**ALLIANCE OF RESIDENTS CONCERNING O'HARE, Inc.**

February 25, 2004

Re. **Docket Number FAA-2003-16526**

ARECO is pleased to provide the following comments in the matter of the FAA's Stage 4 Aircraft Noise Standards rulemaking, 14 CFR Parts 36 and 91, [Docket No. FAA-2003-16526; Notice No.03-12] RIN 2120-AH99

**Figure 1. Distribution of margins in aircraft types using today's best noise reduction practices.**

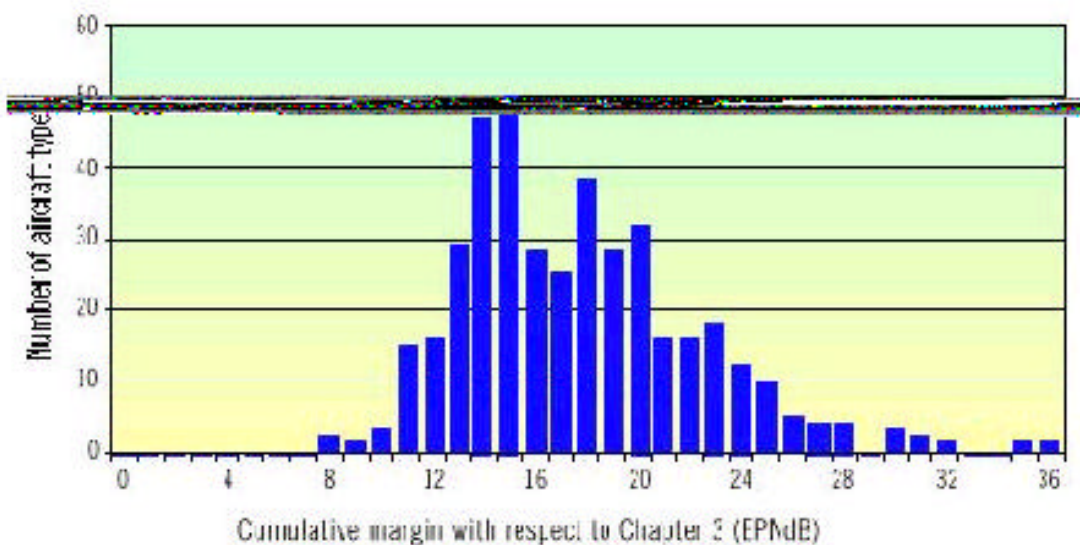
Finally, ICAO imposed the Stage 4 requirement on only new engines produced after 2006, with no retroactive actions applied to the existing fleet (now primarily Stage 3 certified), though it is clear that the intent was to let many as possible of the existing Stage 3 aircraft to file for an upgrade to Stage 4, without any modification. This is evidenced in the ICAO's own chart (Figure 1, below) that clearly (and embarrassingly) shows that just a few of the currently flying aircraft would not meet the new Stage 4 specification (the three small bars on the left...a few percent of the total). The FAA recognizes this fact in the background discussion:

The average layman could observe the above chart and conclude "by eyeball" that a technology driven approach for new aircraft design would call for a Stage 4 minimum specification of about 18dB improvement (which is still actually only a "real" improvement of about 6dB, based on the ICAO and now FAA's "sum of differences" approach, while 10dB of real improvement is required to reduce loudness approximately in half).

- 10dB for ALL planes after 2003 (not just new production)
- 12dB for ALL planes after 2006, -18dB for new plane production
- 15dB for ALL planes after 2010, -20dB for new plane production
- 18dB for ALL planes after 2015, -23dB for new plane production
